**HAMPTON QUAY, LITTLEHAMPTON,
WEST SUSSEX, BN17 5RA**

**DESIGNER'S RESPONSE TO ROAD
SAFETY AUDIT STAGE 1**

Report No.: 18-270-04C

PROPOSED OFFSITE IMPROVEMENTS &
ALLOWANCE FOR FUTURE IMPROVEMENTS

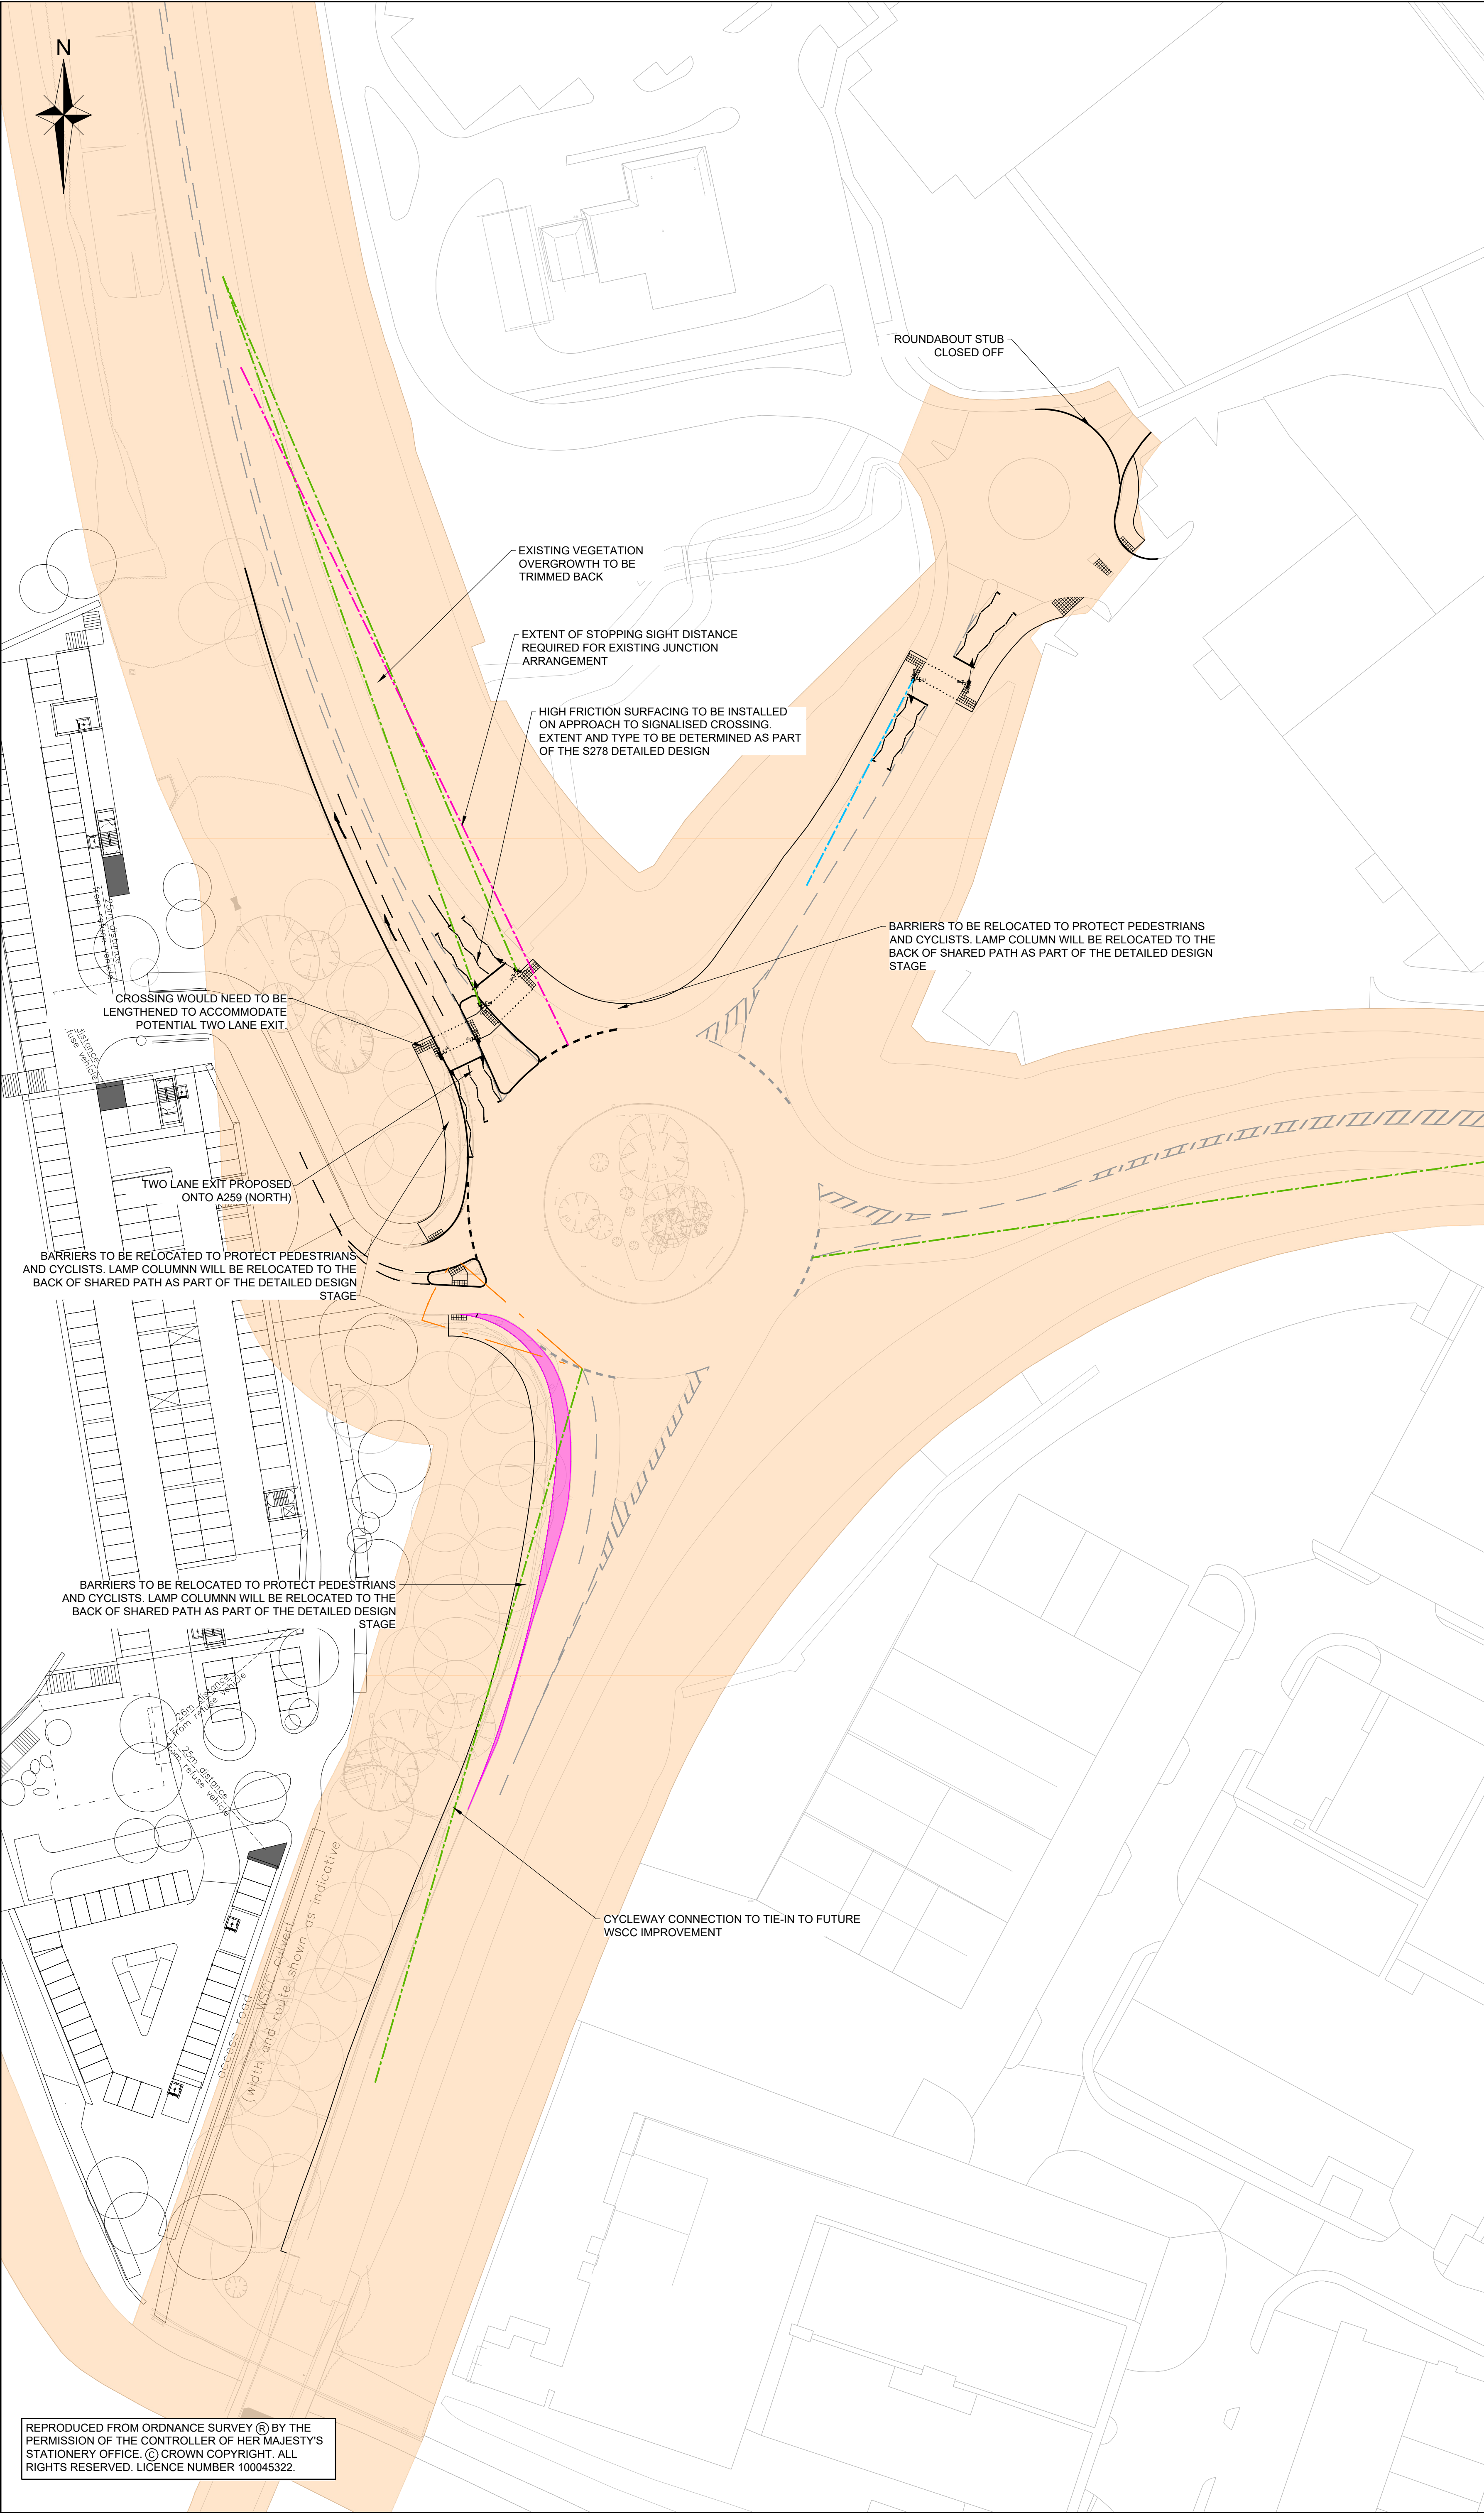
3.2.2	PROBLEM Location: Bridge Road Roundabout – pedestrian crossing point on proposed arm.	It is recommended that the SSD to the crossing should be free from obstruction and provided for assessment.	Drawing 18-270/010 has been revised to show visibility requirements to the pedestrian crossing as per Figure 3.53 in

A fifth arm is proposed on Bridge Road Roundabout, including an uncontrolled pedestrian point. However, no SSD was supplied for assessment, where there is existing excess vegetation. Restricted visibility could lead to vehicle to pedestrian / cyclist collisions or rear end shunts.

It is recommended that the SSD to the crossing should be free from obstruction and provided for assessment.

VISIBILITY TO PEDESTRIAN CROSSING
(DRAWN IN ACCORDANCE WITH FIGURE 3.53 OF CD116)

120m STOPPING SIGHT DISTANCE (UPTO 44mph DMRB)

37m STOPPING SIGHT DISTANCE (28mph MfS)

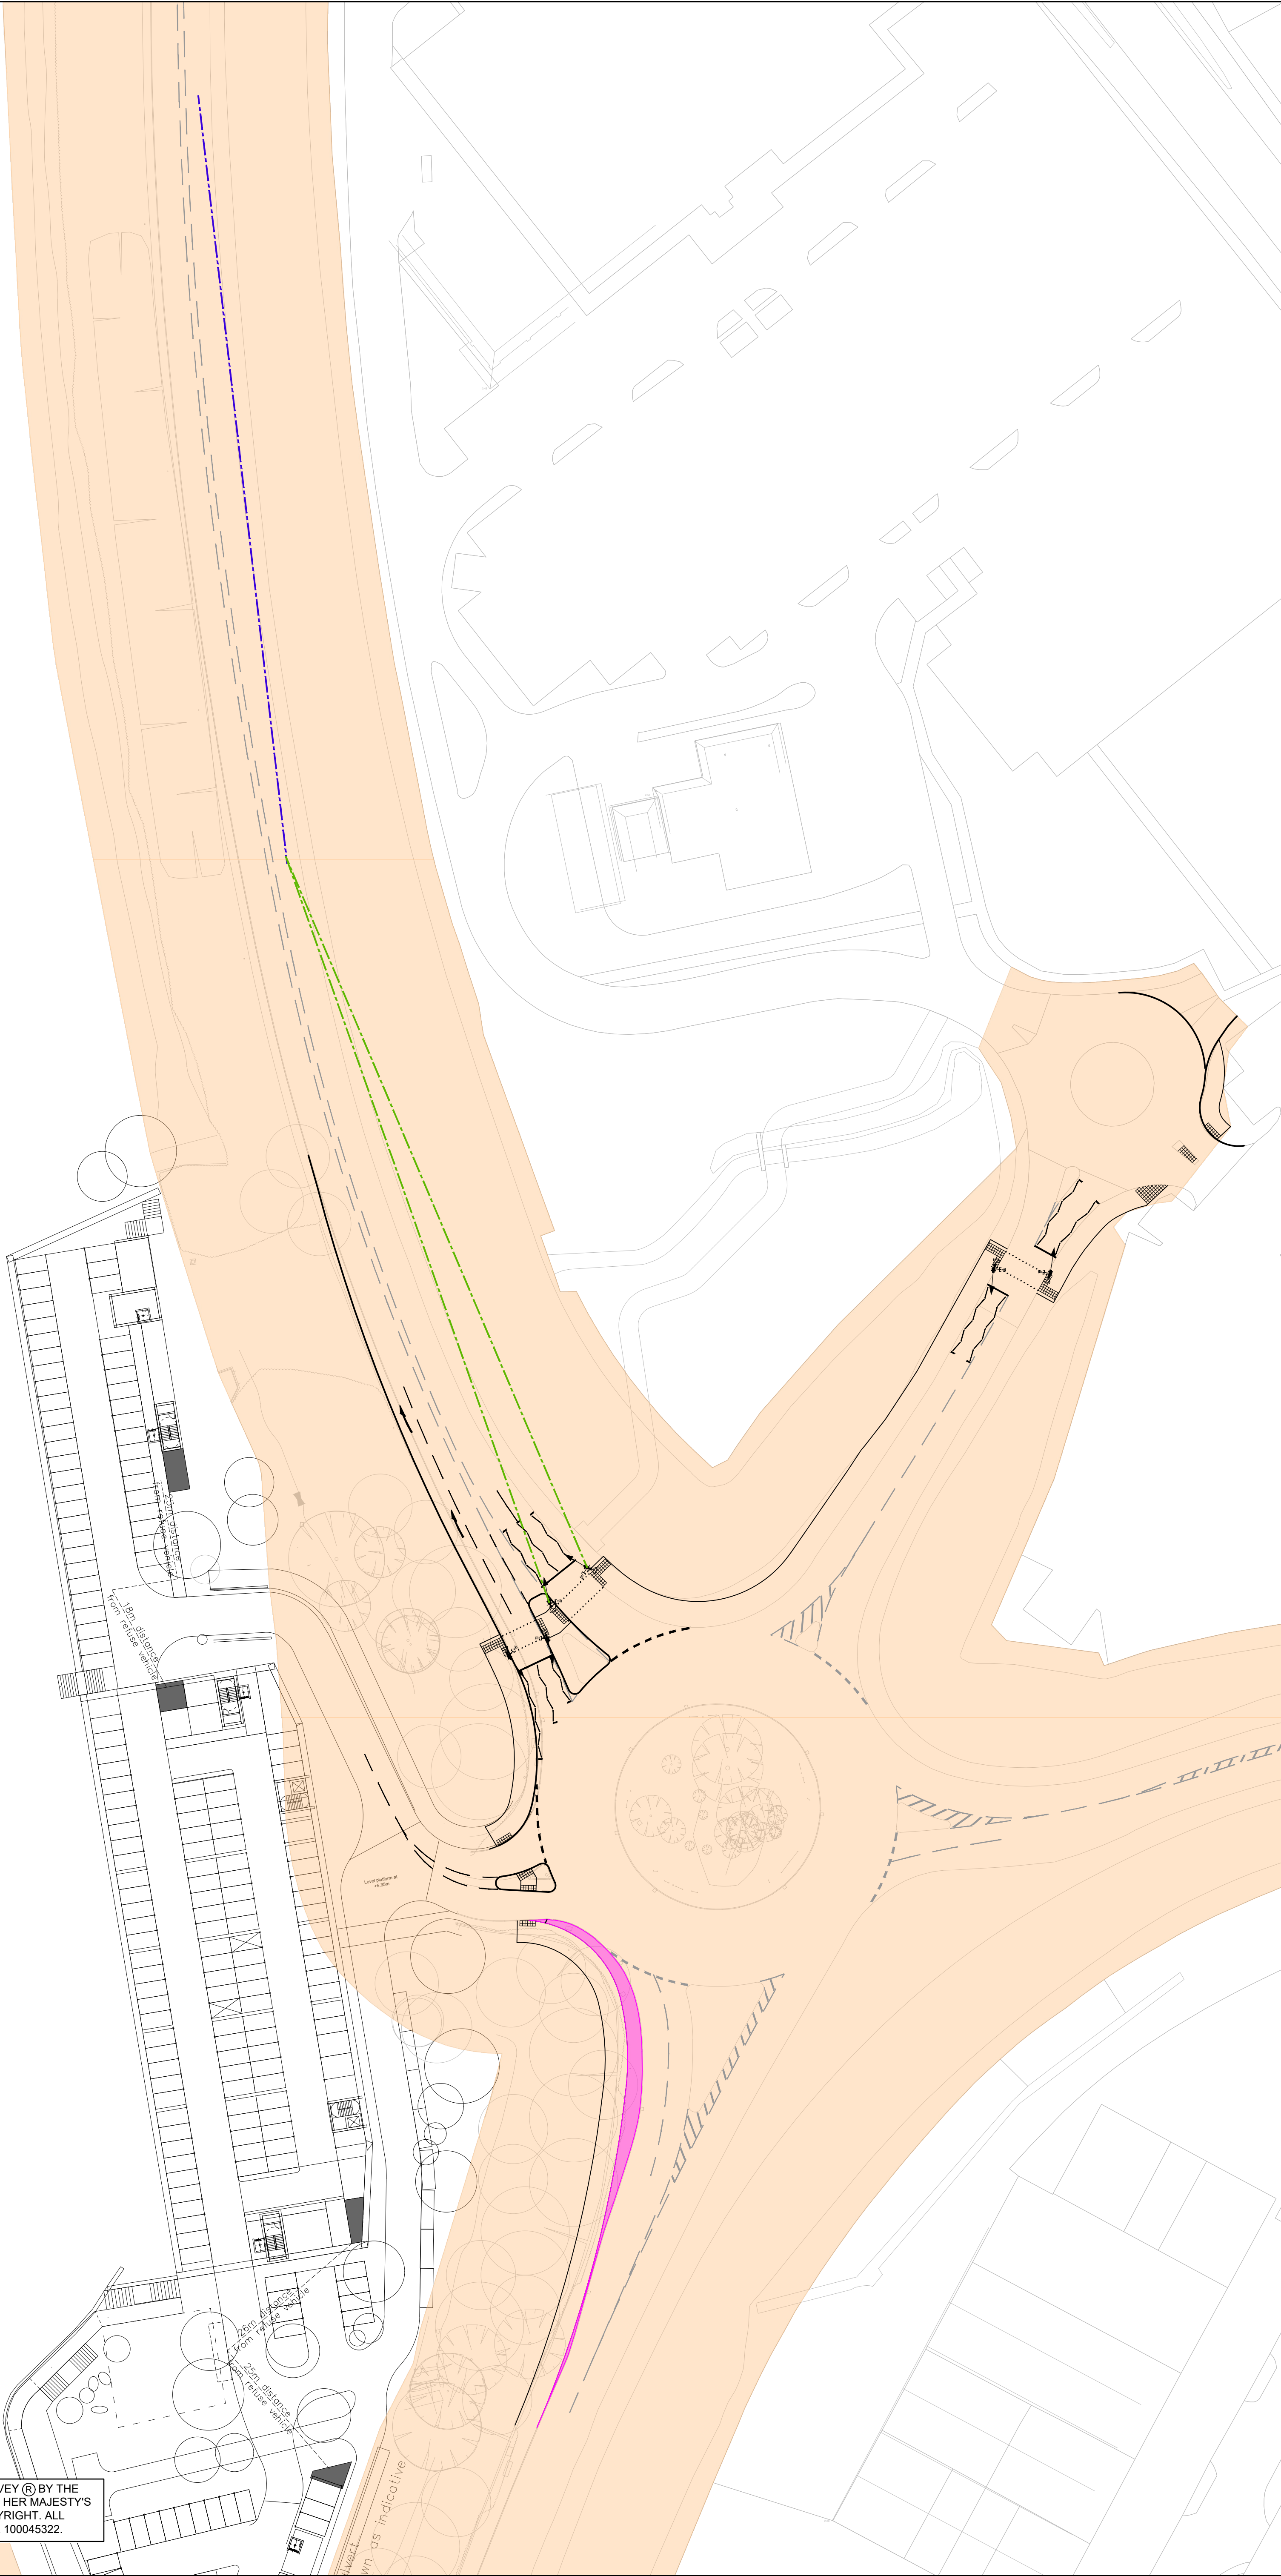
The A259 southern approach is curved and visibility splays pass over the adjacent verge that is restricted due to vegetation – see figure 2 overleaf. Stopping Sight Distances (SSDs) were supplied for assessment and were shown at 120m to the stop line and signal aspects commensurate with 44mph speeds in DMRB. However, this does not take into account the rear of any queue that could have developed due to the crossings being in operation where

It is recommended that SSDs, visibility to signal aspects and the rear of any queue should be free from obstruction and commensurate with vehicle speeds, where it is observed that the A259 straightens away from the roundabout.

- NOTES
- KEY
- POTENTIAL WIDER A259 IMPROVEMENTS
 - HIGHWAY BOUNDARY
 - 120m STOPPING SIGHT DISTANCE TO THE BACK OF PREDICTED FORECAST YEAR 2038, PM PEAK QUEUE
 - 120m STOPPING SIGHT DISTANCE (UPTO 44mph DMRB)
